Subject: DRAFT Response to U.S. EPR Design Certification Application RAI No. 370,
FSAR Ch. 3, Question 3.7.2-64
Sent Date: 2/17/2012 2:54:09 PM
Received Date: 2/17/2012 2:53:54 PM
From: WILLIFORD Dennis (AREVA)

Request for Additional Information No. 370

U.S. EPR Standard Design Certification

Question 03.07.02-64:**Follow Up to RAI 248, Question 03.07.02-53:**

Figure 03.07.02-64-1—Soil Case 2sn4ue: Dynamic Bearing Pressure Distribution for EUR motions for NAB with 50 Percent Reduced Flexural Stiffness

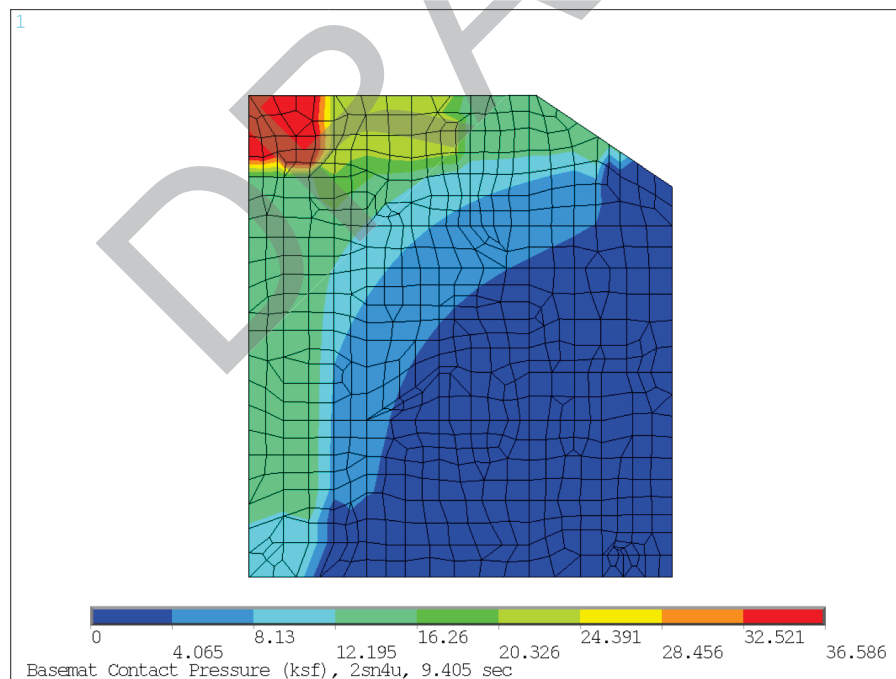
The applicant has proposed utilizing a lateral-force resisting system (LFRS) with a controlled collapse zone as the design basis for the NAB under an SSE event. In order for the staff to evaluate the acceptability of this design feature and whether it meets Acceptance Criteria 8 of SRP 3.7.2, the staff is requesting the following additional information:

7. A description of the method used to calculate the seismic displacement of the NAB from which it is concluded that the gap between the NAB and Safeguard building (SB4) and the gap between the NAB and Fuel Building is sufficient to prevent an interaction with these adjacent Category I structures.

8. The results of an analysis that demonstrates that the NAB does not slide or overturn into adjacent Category I structures.
9. The interaction between the LFRS and the controlled collapse zone including the collapse or impact loads that are expected to be applied to the LFRS by the collapse zone.

The NAB stability model is used to calculate the bearing pressures as well as maximum lateral displacements of the NAB structure.

- Factor of Safety is based on original gap distance of 18 inches between NI and NAB in both X and Y directions.
